SIERRA
CLUB
ONTARIO

Report from Sierra Club Ontario's Great Lakes section member Bill Bialkowski, an engineer with extensive professional experience dealing with flow dynamics

On May 26, 2011 the IUGLS issued its report "Options for Restoring Lake Michigan-Huron Water Levels", which was carried at the specific request of the IJC. It is based on a simulation of the upper Great lakes from Sault Ste Marie to the Port of Montreal. The report confirms that it is feasible to restore the levels of Lake MH by 10, 25, 40 or 50 cm, the four scenarios requested by the IJC, and that if the conveyance capacity could be reduced instantaneously, it would take Lake MH about 10 years to 'fill' to the required level. In the meantime there would be temporary reductions in the downstream flows, and this would have short term impacts on downstream interests. The downstream impacts can be lessened by staging the conveyance capacity reductions over time. The IUGLS chose to have five small 'projects' staged every five years, hence taking 20 years to complete.

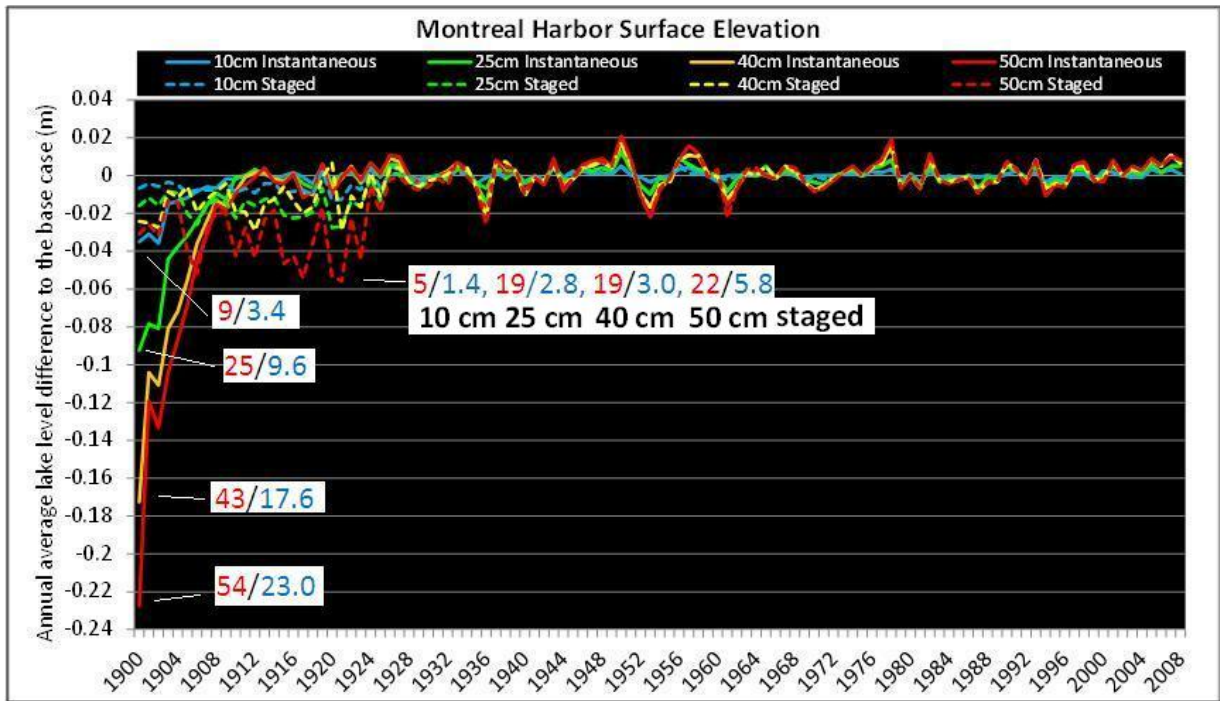
The downstream impacts are listed in the report's Table 3-3 and include both instantaneous and staged results for all four scenarios. The results list surprising large and unexpected downstream impacts as far down as the level at the Port of Montreal, for which level reductions of 25 and 19 cm are listed. There are very large reductions in flow below Lake Ontario due apparently to the way the Lake Ontario regulation Plan 1958DD works. A careful analysis of the simulation graphs reproduced a set of equivalent level and flow results. None of the values claimed in Ref 1 Table 3-3 agree with the graphical results. All the Table 3-3 results are bigger by amounts ranging from 20% to as large as a factor of about 7. As an illustration Figure E1 below shows the level at the Port of Montreal – a graph reproduced from the IUGLS report. The values for various instantaneous and staged changes have been superimposed on the graph. Those claimed in Table 3-3 are superimposed in red, while the graphically derived values are superimposed in blue. It is quite easy to judge the relative accuracy of these results relative to the graph vertical scale (note: while the discussion is in cm, the graph is in metres, hence 0.24 means 24 cm, while 0.2 means 20 cm).

Figure E1: level at Jetty 1, Port of Montreal from IUGLS report Fig 3-12. For restoration values of 10, 25, 40 & 50 cm the Table 3-3 and independently derived graphical values are: a) instantaneous: 9/3.4, 25/9.6, 43/17.6, 54/23.0, and b) staged: 5/1.4, 19/2.8, 19/3.0, 22/5.8. Note all Table 3-3 values are higher than graphically derived values (some are actually off-scale on the graph). The 25 cm and 40 cm restoration staged results both claim 19 cm, while their graphical values of 2.8 and 3.0 cm.
